Subject: Waterford 3 SES
Docket No. 50-382
License No. NPF-38
Technical Specification Change Request NPF-38-239
Revision of Letdown Line Break Dose Consequences

Attachment 1: Description and No Significant Hazards Consideration Determination
Attachment 2: Proposed TS Marked-up
Attachment 3: Proposed FSAR Marked-up

PROPOSED MARKED-UP TECHNICAL SPECIFICATION

PROPOSED MARKED-UP UPDATE FINAL SAFETY ANALYSIS REPORT

FIGURE 3.4-1

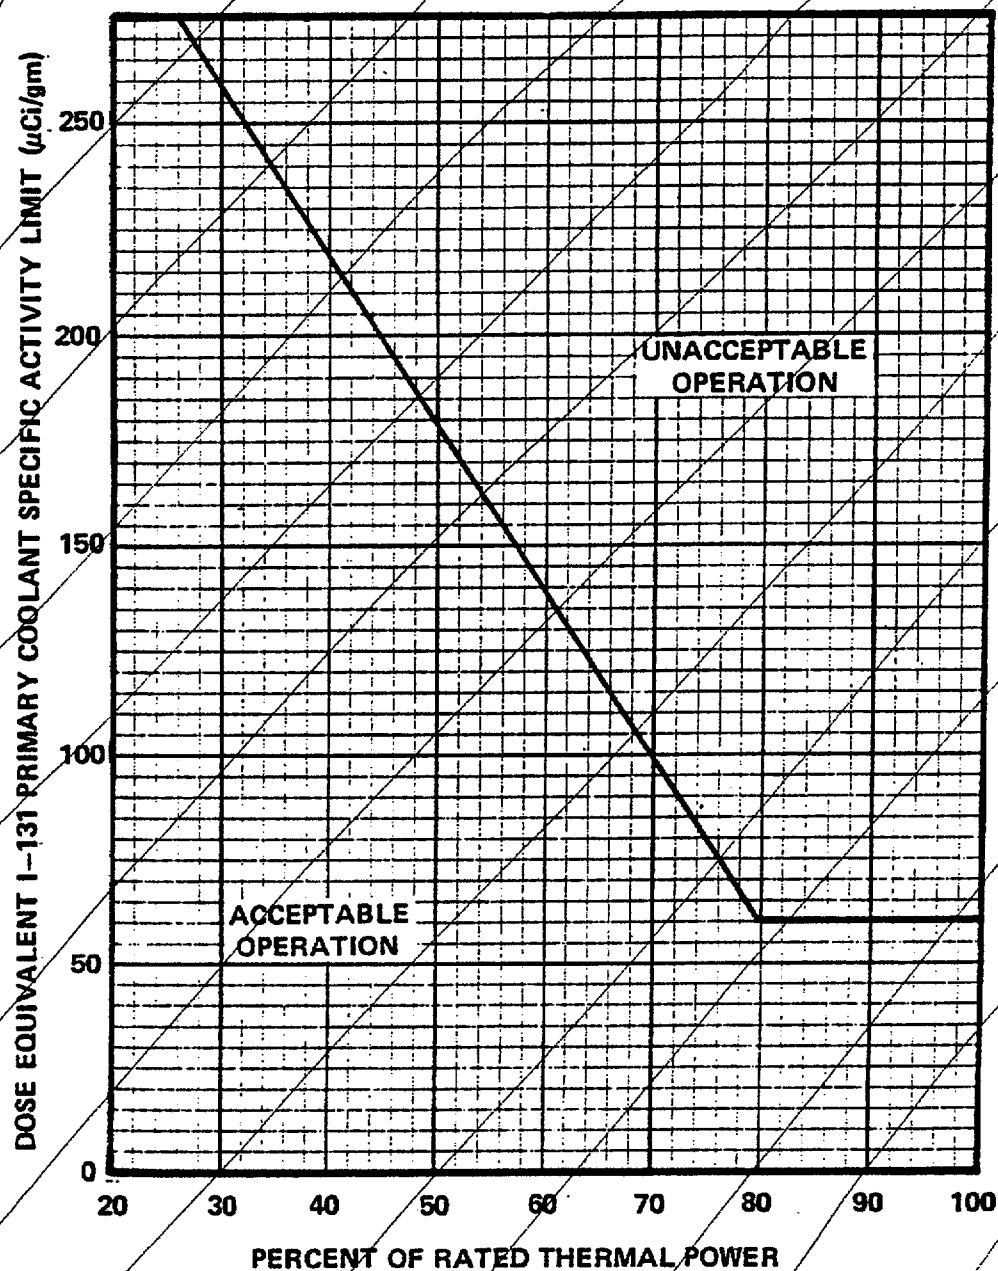
<u>FIGURE</u>		<u>PAGE</u>
3.1-1	REQUIRED STORED BORIC ACID VOLUME AS A FUNCTION OF CONCENTRATION.....	3/4 1-13
3.4-1	DELETED DOSE EQUIVALENT I-131 PRIMARY COOLANT SPECIFIC ACTIVITY LIMIT VERSUS PERCENT OF RATED THERMAL POWER WITH THE PRIMARY COOLANT SPECIFIC ACTIVITY >1.0μCi/GRAM DOSE EQUIVALENT I-131.....	3/4 4-27
3.4-2	REACTOR COOLANT SYSTEM PRESSURE/TEMPERATURE LIMITATIONS FOR 0-8 EFFECTIVE FULL POWER YEARS (HEATUP).....	3/4 4-30
3.4-3	REACTOR COOLANT SYSTEM PRESSURE/TEMPERATURE LIMITATIONS FOR 0-8 EFFECTIVE FULL POWER YEARS (COOLDOWN).....	3/4 4-31
4.7-1	SAMPLING PLAN FOR SNUBBER FUNCTIONAL TEST.....	3/4 7-26
5.1-1	EXCLUSION AREA.....	5-2
5.1-2	LOW POPULATION ZONE.....	5-3
5.1-3	SITE BOUNDARY FOR RADIOACTIVE GASEOUS AND LIQUID EFFLUENTS.....	5-4
6.2-1	OFFSITE ORGANIZATION FOR MANAGEMENT AND TECHNICAL SUPPORT.....	6-3
6.2-2	PLANT OPERATIONS ORGANIZATION.....	6-4

- a. With the specific activity of the primary coolant greater than 1.0 microcurie/gram DOSE EQUIVALENT I-131 for more than 48 hours during one continuous time interval or exceeding 60 microcuries/gram DOSE EQUIVALENT I-131 ~~the limit line shown in Figure 3.4-1,~~ be in at least HOT STANDBY with T_{avg} less than 500 °F within 6 hours.
- b. With the specific activity of the primary coolant greater than $100/\bar{E}$ microcuries/gram, be in at least HOT STANDBY with T_{avg} less than 500 °F within 6 hours.

The proposed change to the Technical Specifications (TS) conservatively limits Reactor Coolant System (RCS) activity permitted by action statement 3.4.7.a to 60 $\mu\text{Ci/gm}$ at all reactor power levels. This change will be implemented by deleting Figure 3.4-1 and incorporating the proposed limit into the action statement 3.4.7.a.

Figure
15.6-1

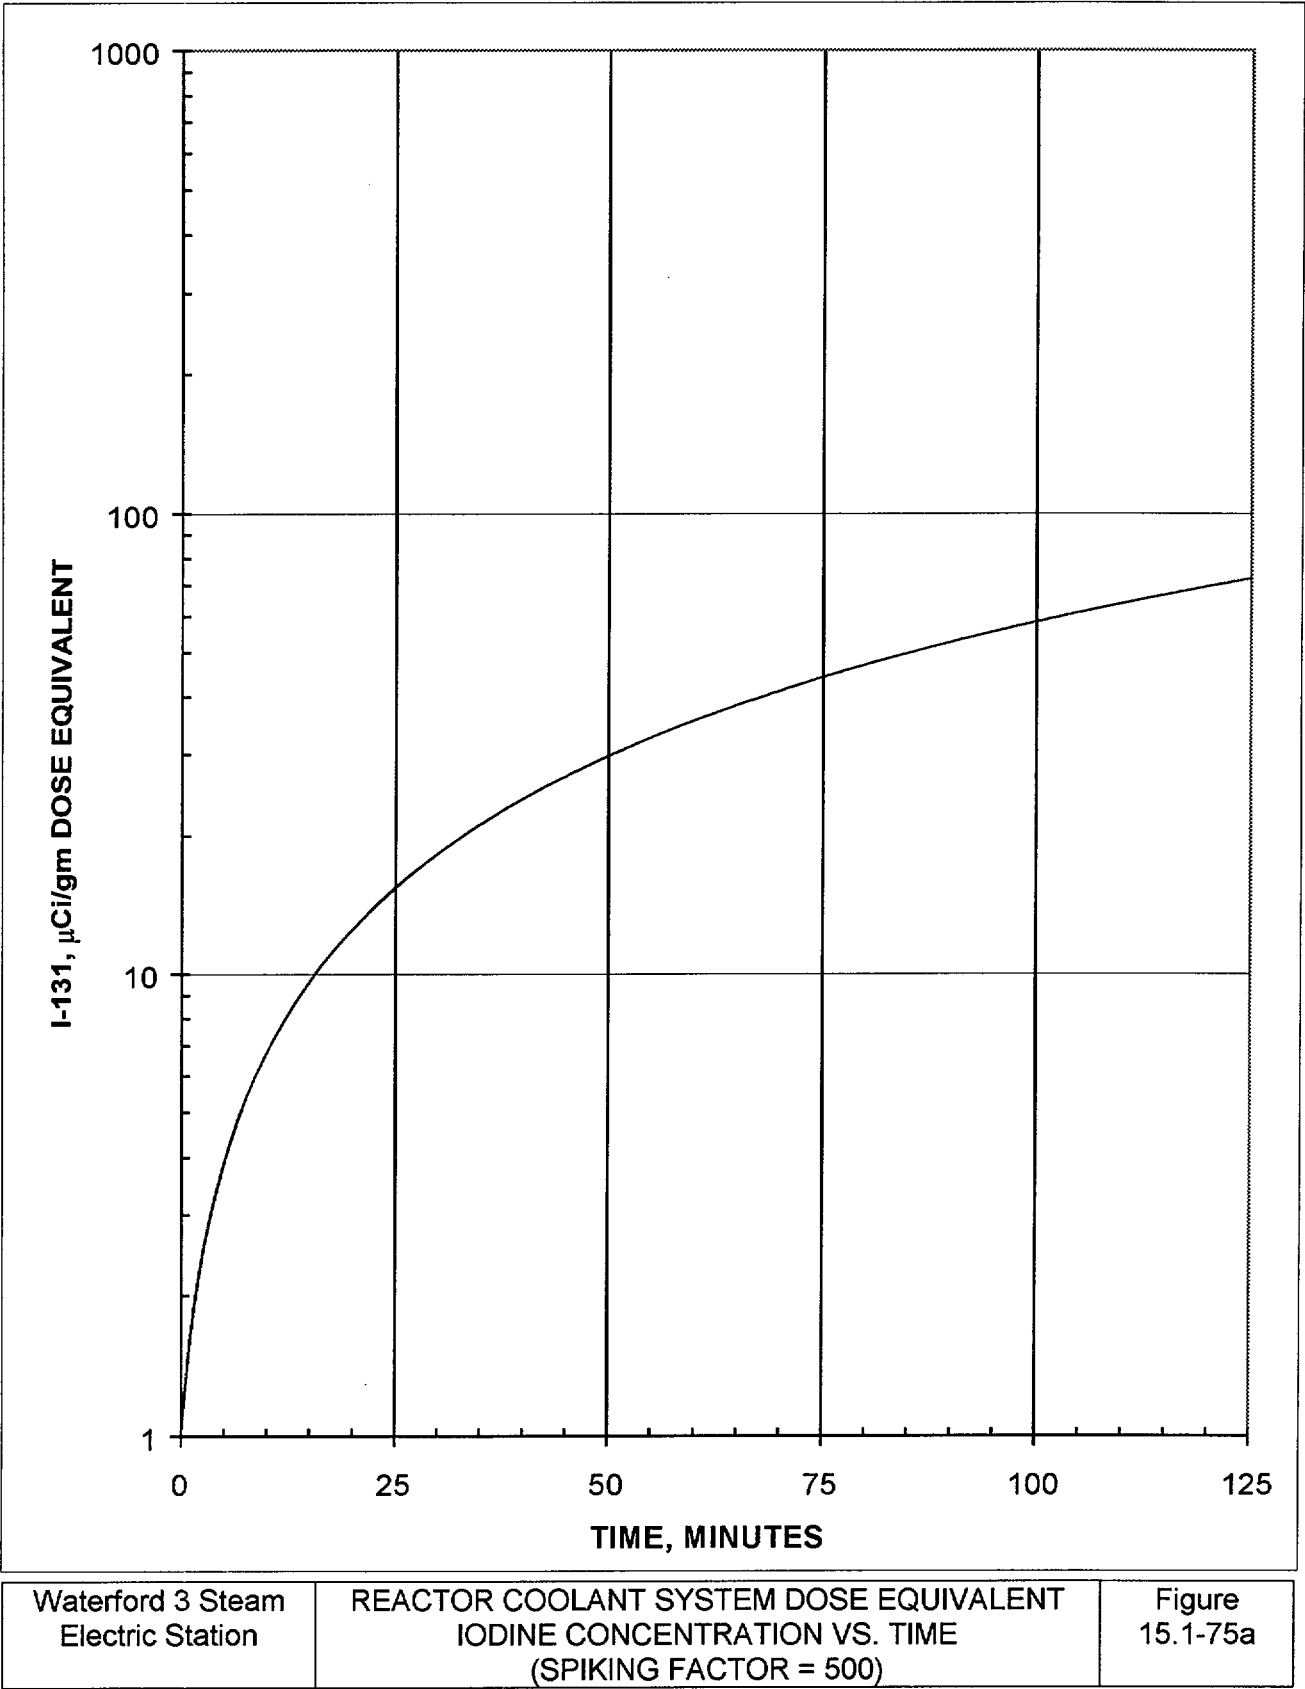
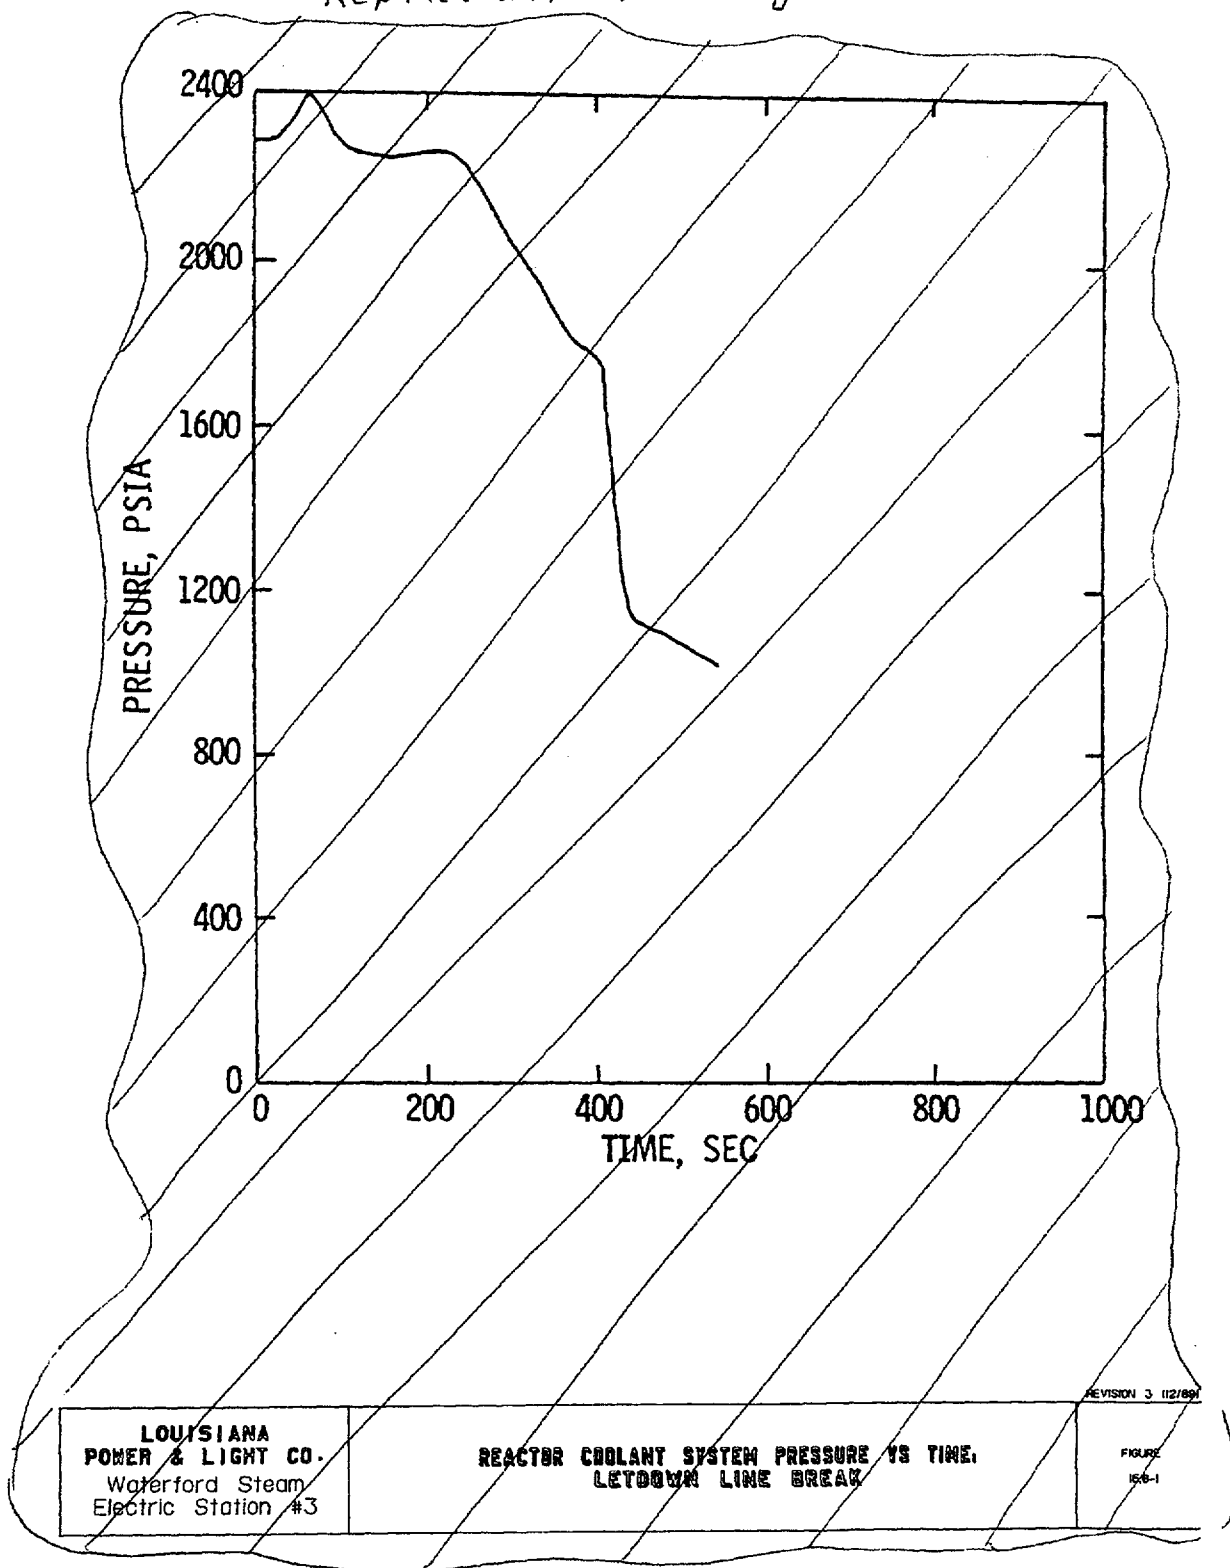
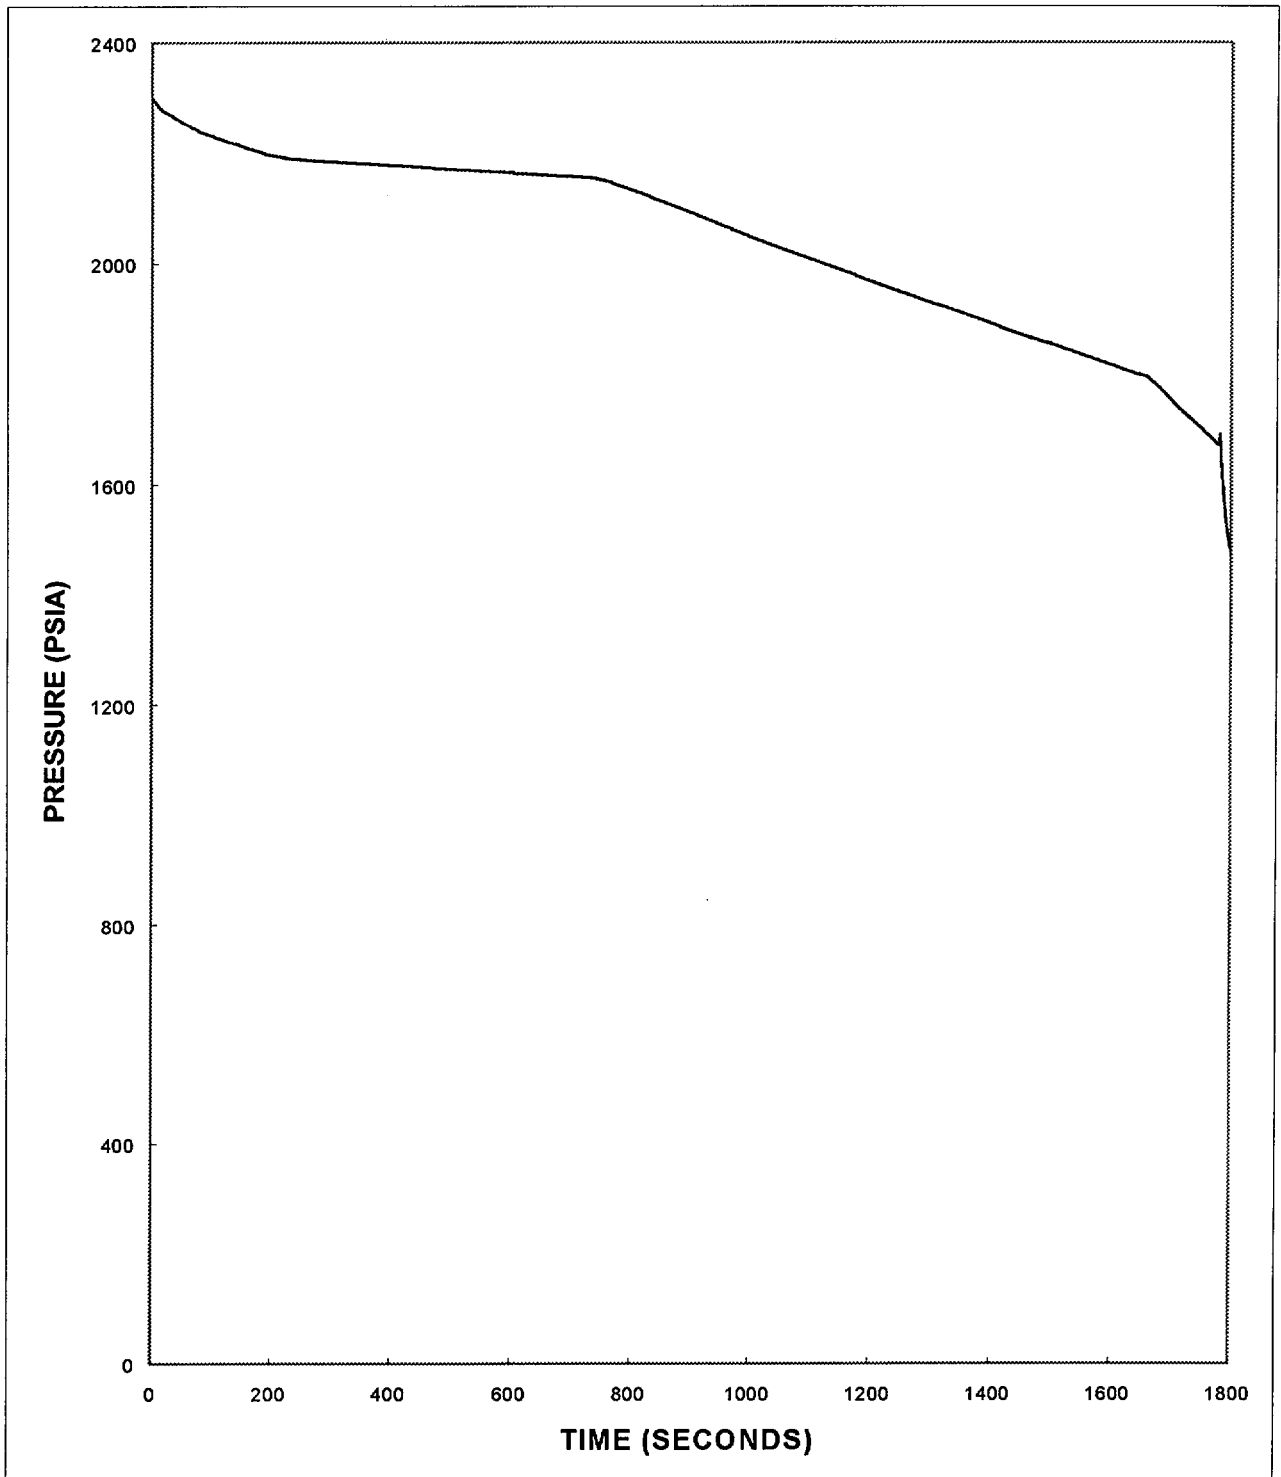
New Figure

Replace with new figure 15.6-1

The response of the NSSS following a letdown line break begins with a decrease in pressurizer level and pressure. The decreasing pressure transient is shown in Figure 15.6-1. At approximately 4061780 seconds after the break, ~~pressurizer pressure has dropped to the CPC low pressure floor and a reactor trip is initiated on low DNBR~~ RCS pressure has decreased such that the calculated CPC saturation temperature is exceeded by the hot leg temperature and a reactor trip is initiated. The turbine trip on reactor trip results in an increase in secondary side pressure to the steam generator safety valve set pressure. An SIAS is also generated on low pressurizer pressure, isolating the letdown line and terminating the break flow at about 4261800 seconds.
